4. TITLE AND SUBTITLE
ONPOST/OFFPOST GROUND/SURFACE WATER MONITORING PROGRAM, TASK 44, FINAL
TECHNICAL PLAN

ENVIRONMENTAL SCIENCE AND ENGINEERING
DENVER, CO8. PERFORMING ORGANIZATION
REPORT NUMBER

ROCKY MOUNTAIN ARSENAL (CO.). PMRMA
COMMERCE CITY, CO10. SPONSORING/MONITORING
AGENCY REPORT NUMBER

8.1 GROUND_WATER	8-1
8.2 SURFACE_WATER	8-4
9.0 REFERENCES	9-1
APPENDIX A--COMMENTS AND RESPONSES TO THE DRAFT FINAL TECHNICAL PLAN, NOVEMBER 1987	
APPENDIX B--TASK 44 FINAL LETTER TECHNICAL PLAN, FEBRUARY 10, 1988 AND COMMENTS AND RESPONSES TO THE DRAFT FINAL LETTER TECHNICAL PLAN, APRIL 29, 1987

Figure 9
PROPOSED TASK 44 ON-POST ALLUVIAL MONITORING
WELL NETWORK AND INFERRED
BEDROCK PALEOCHANNELS

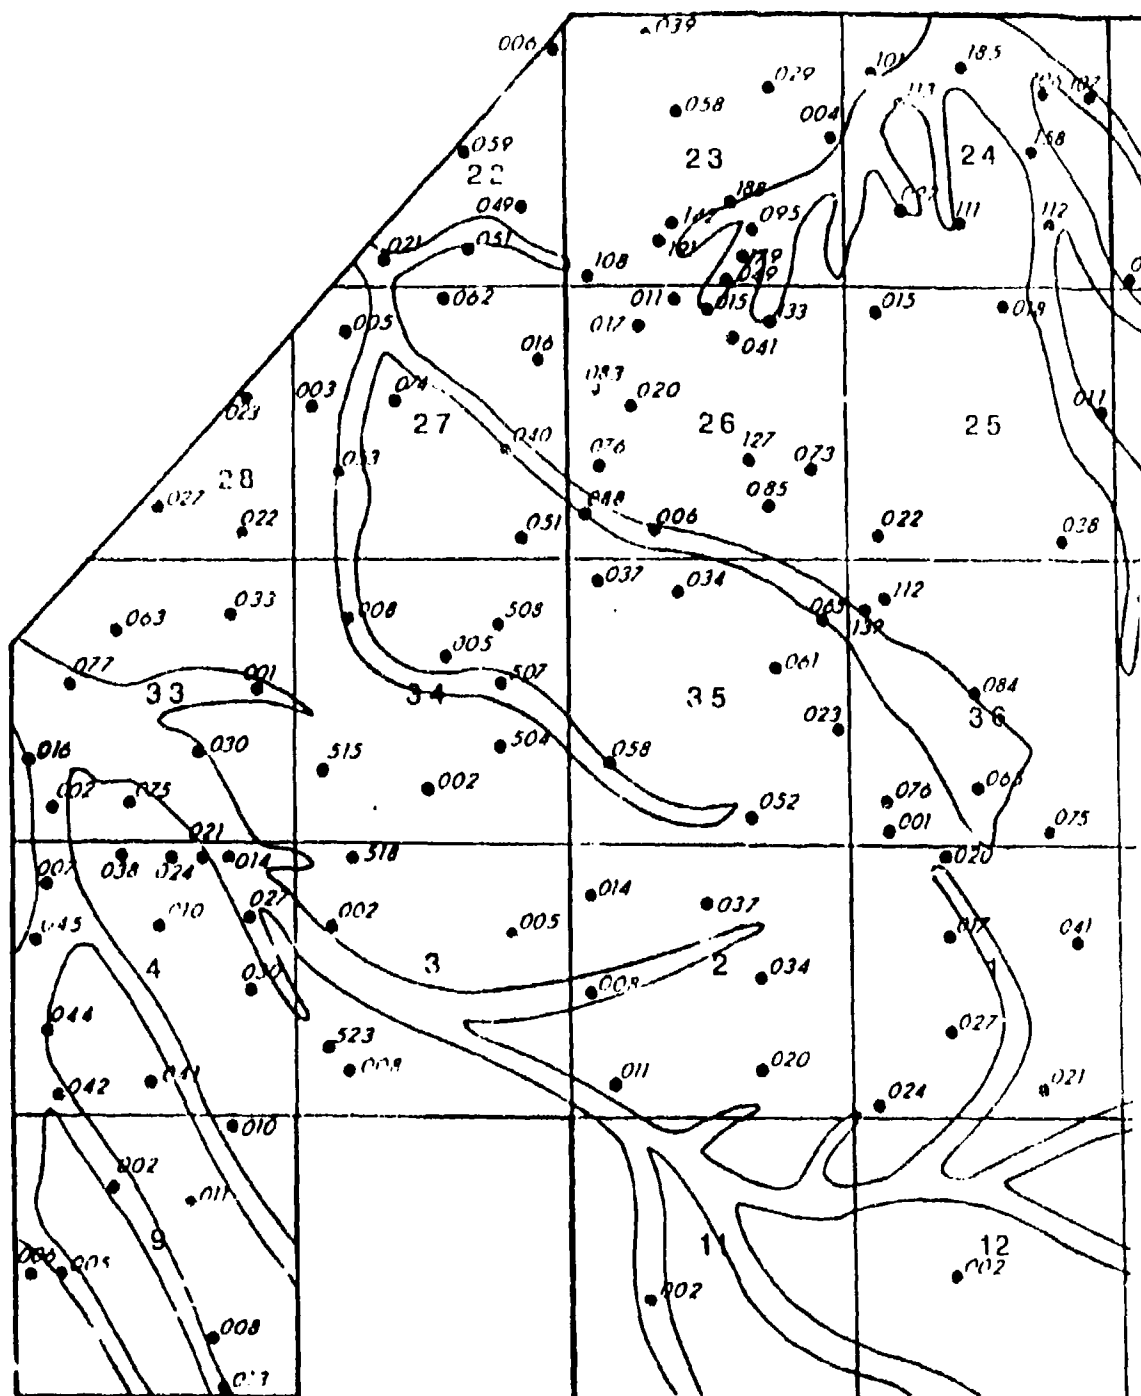
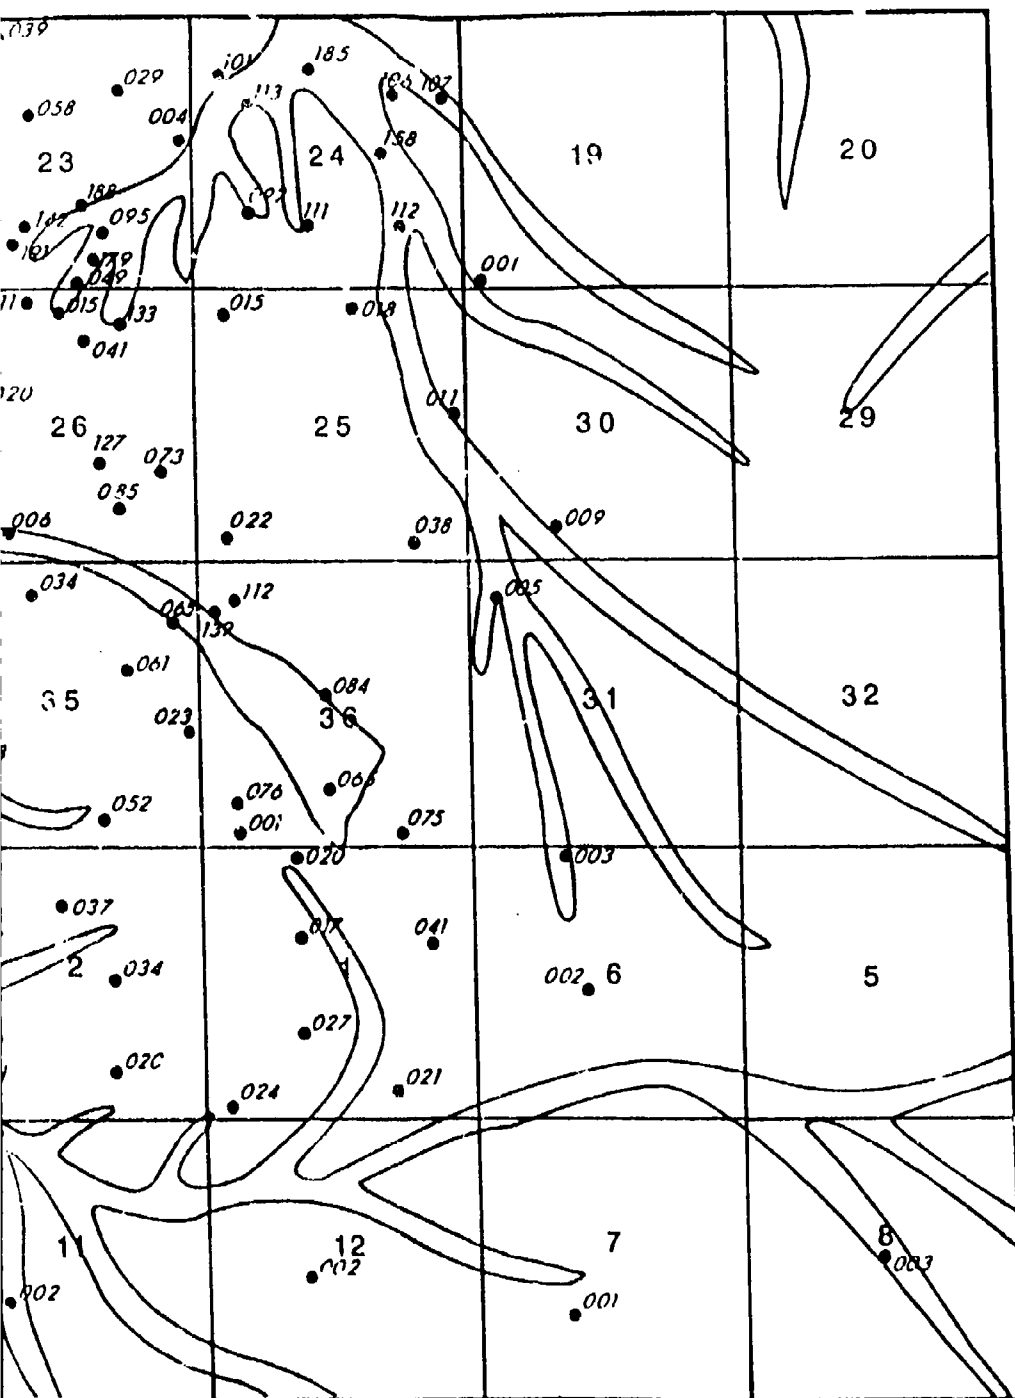
P.11 A comparison of Figures 5 and 9 indicates that the paleochannel map was prepared using excessive extrapolation. For example, Figure 9 shows three separate northwest trending channels beneath Sections 4 and 9 based on two data points (09002 and 09005) within a "channel." There is not a single data point in the northernmost channel (shown to extend for 1-1/2 miles). Similarly, in Section 3 and other areas where paleochannels are shown, little or no data exists to establish the location and orientation of the channels. The Task 44 program should not be focused on "inferred" or imagined channels. The monitoring well network and these figures should be modified accordingly.

Inferred bedrock paleochannels were not constructed based on the data points (well locations) shown on Figure 9. As stated on Page 11 of the Letter Technical Plan, the paleochannel map was prepared from available geologic information. This information included boring logs, bedrock contour maps, and alluvial thickness maps. Therefore, the locations of
